FORT CALHOUN
TECHNICAL SPECIFICATIONS

JUSTIFICATION, DISCUSSION, AND SIGNIFICANT HAZARDS CONSIDERATIONS FOR HEATUP AND COOLDOWN CURVES

The Fort Calhoun Technical Specifications are being amended to update the current heatup and cooldown limit curves for continued safe operation of the reactor vessel and associated primary coolant system beyond 8.5 Equivalent Full Power Years (EFPY). This application requests continued operation through 15 EFPY.

FIGURE
2-1A

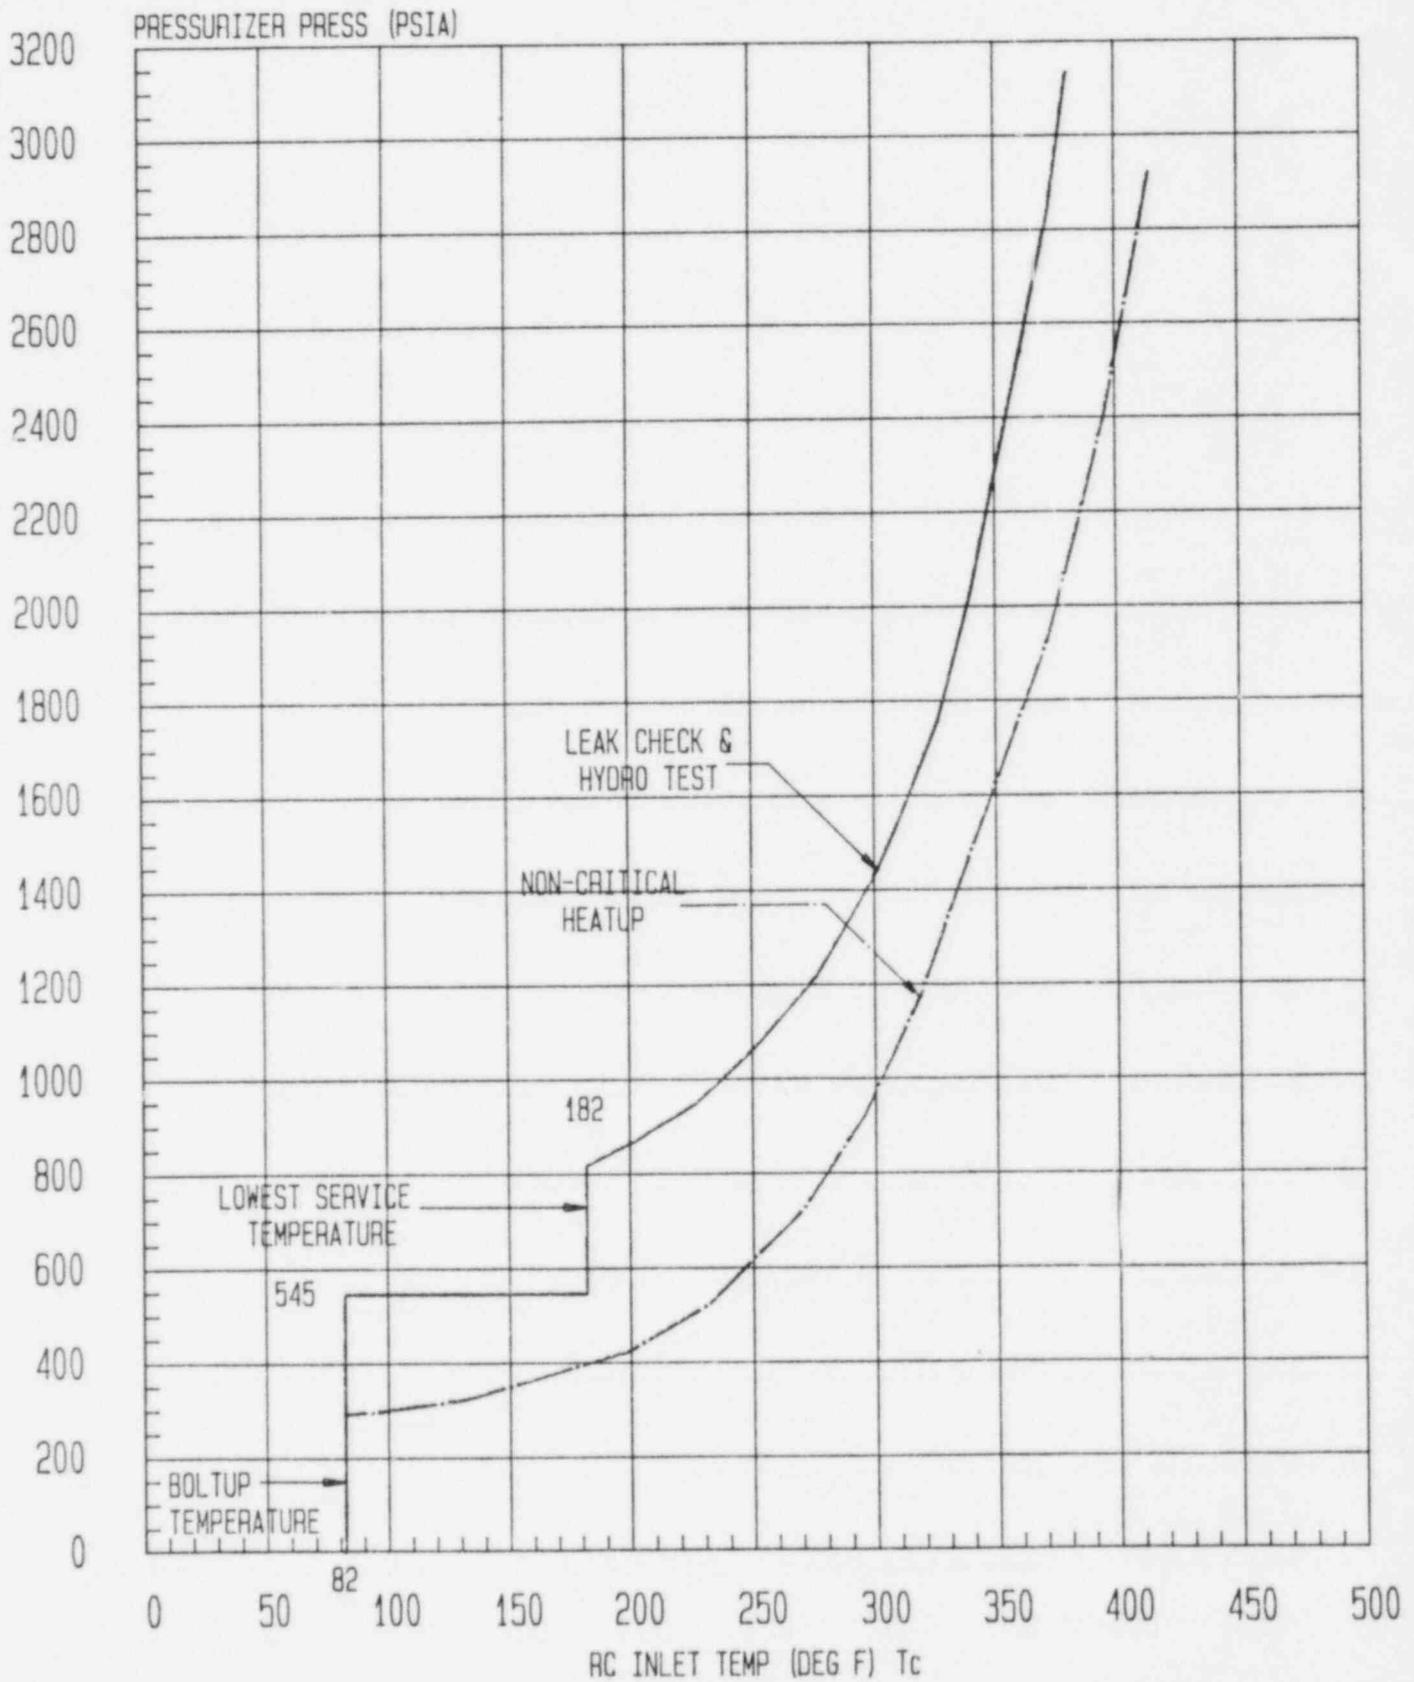
The 100°/hour heatup curves for the 3/4t should be included.

There are no pressure temperature limits for heatup or cooldown for the reactor critical.

Response: The District's submittal will include 3/4t curves when they are limiting.

Response: The District removed these curves via a previous amendment. They are not restrictive since present Technical Specifications require all 4

reactor coolant pumps to be in operation prior to criticality. Additionally, the inlet temperature must be at least 515°F prior to criticality. The only exception is for physics testing when the power level shall be $10^{-1}\%$ or less. Further, the reactor cannot be made or maintained critical unless the inlet temperature is NDTT + 120°F. These restrictions are delineated in Technical Specification sections; 2.1.1(1), 1.3 Table 1.1 No. 2, 2.10.1(1), and 2.10.1(2) which are located on pages 2-1, 1-10a and 2-48, respectively. The District feels that incorporating additional if not less restrictive guidance could be confusing and lead to a violation of the more restrictive requirements.

RCS PRESS-TEMP LIMITS COOLDOWN

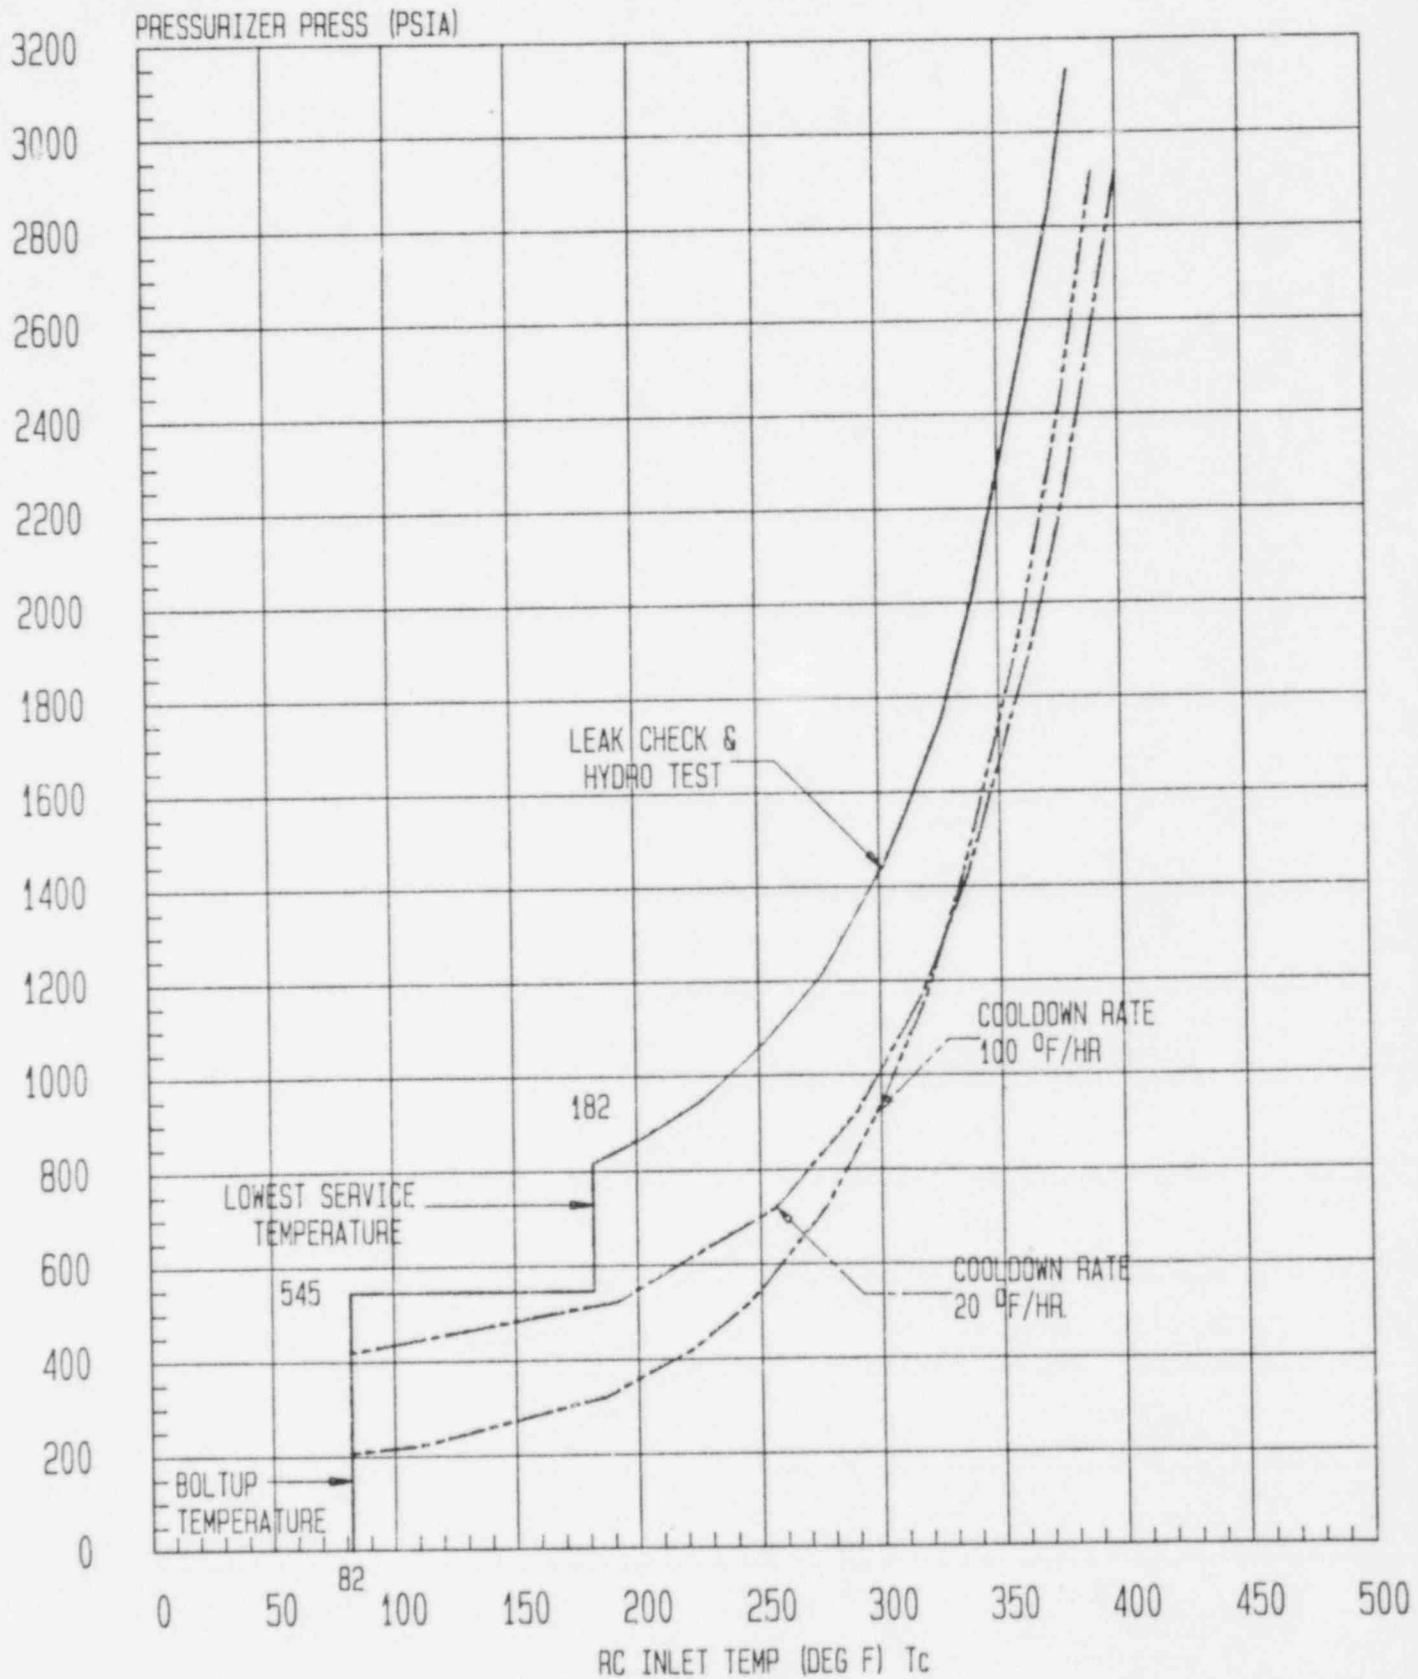
Staff calculates 20% of the pre-service system hydro test pressure as $0.2 \times 1.25 \times 2500 = 625$ psia vs the 545 psia in the submittal. Why the discrepancy?

How did OPPD obtain $162^\circ F$ for lowest service temperature? Staff calculates $182^\circ F$.

Response: No discrepancy exists. The calculation from the 625 psia to 545 psia is clearly stated in the current Technical Specifications on page 2-7 in section 2.1.2.C.

Response: The District concurs that $182^\circ F$ should be used and that the revised submittal will incorporate a lowest service temperature of $182^\circ F$.
